Cambridge Southeast Transport (CSET) Greater Cambridge Partnership Public Consultation

Prepared by Colin M. Harris
14 December 2020 (v1)

cambridge
connect

Figure 2. The Shelford Rail Alignment compared against the 'Offline Alignment' adopted by the GCP for progression (Map: Cambridge Connect 2020).

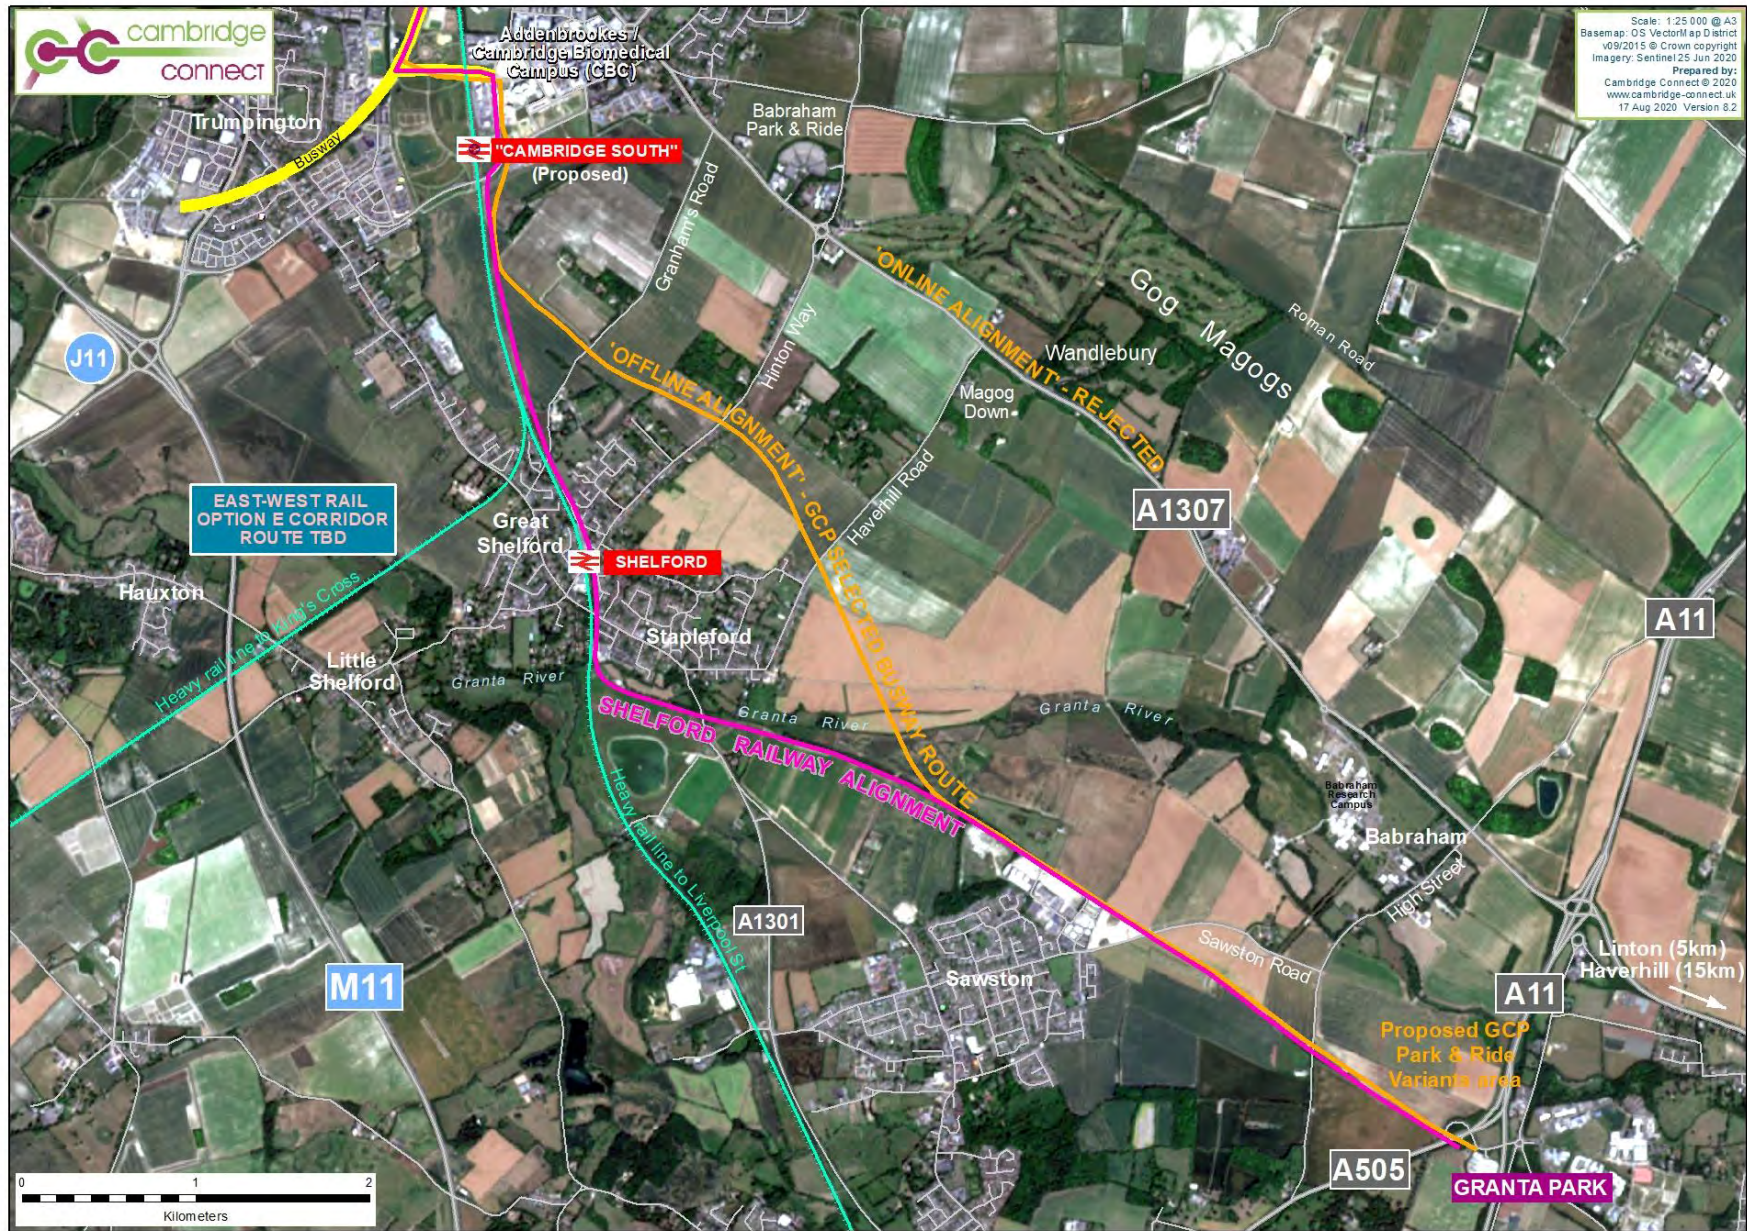
Notwithstanding the above views regarding light rail, we recognise the Greater Cambridge Partnership (GCP) has presently committed itself to bus-based solutions. In the context of this response to the public consultation therefore, our focus is on the selection of route rather than the mode of vehicle that would travel on that route. We have therefore made our evaluation of proposals for a fully segregated bus road following the Shelford Rail Alignment (Figure 2), not light rail.

Our evaluation is informed in part by detailed evidence developed by an independent evaluation of the option of a public transport route from Granta Park to Addenbrookes that broadly follows the Shelford Rail Alignment (Figure 2). This evaluation was commissioned by the Parish Councils of Great Shelford and Stapleford in 2020 and undertaken by the professional transport specialist consultants i-Transport, London. Specifically, this professional review critically examined evidence underpinning the report to the GCP prepared by Mott MacDonald published in May 2020.

- 7.3.1 The GCP route makes an unnecessary incursion into Green Belt and development of major infrastructure for a busy transport route across relatively tranquil and unspoiled rural landscapes of high aesthetic value. It will impact local ecology and recreational uses. It will create additional severance of the Gog Magog Hills and Magog Down from local communities. These values have not been given sufficient consideration in the decision to proceed with this route.

- 7.3.2 The GCP route requires major new land-take from the Green Belt. There is insufficient justification for this because a feasible route through Great Shelford and Stapleford exists utilising the existing transport corridor and the former railway line.

Figure 4: Croydon Tramlink alignment immediately west of Beckenham Junction station. The light rail line is at far left, while the remaining three lines are heavy rail. (Image: Google Maps 2019).

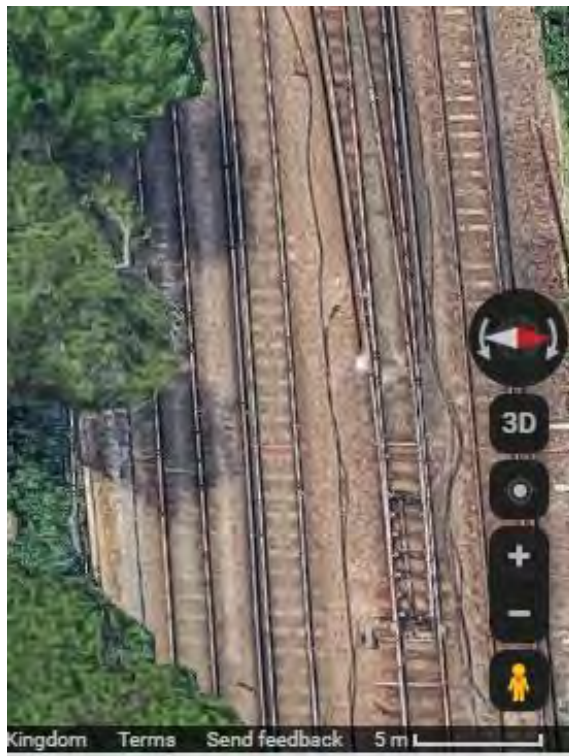
- 7.1.17 A preliminary examination of Croydon Tramlink shows that it is possible to align a light rail line alongside a heavy rail line with minimal separation (Figure 4). While we have not carried out detailed investigations, this suggests that a light rail line along the Great Shelford route may be significantly more feasible, and perhaps less costly in some respects, than the proposed busway. For example, it is likely to have narrower width requirements, and require fewer physical barriers to separate the railway from the public transport route.
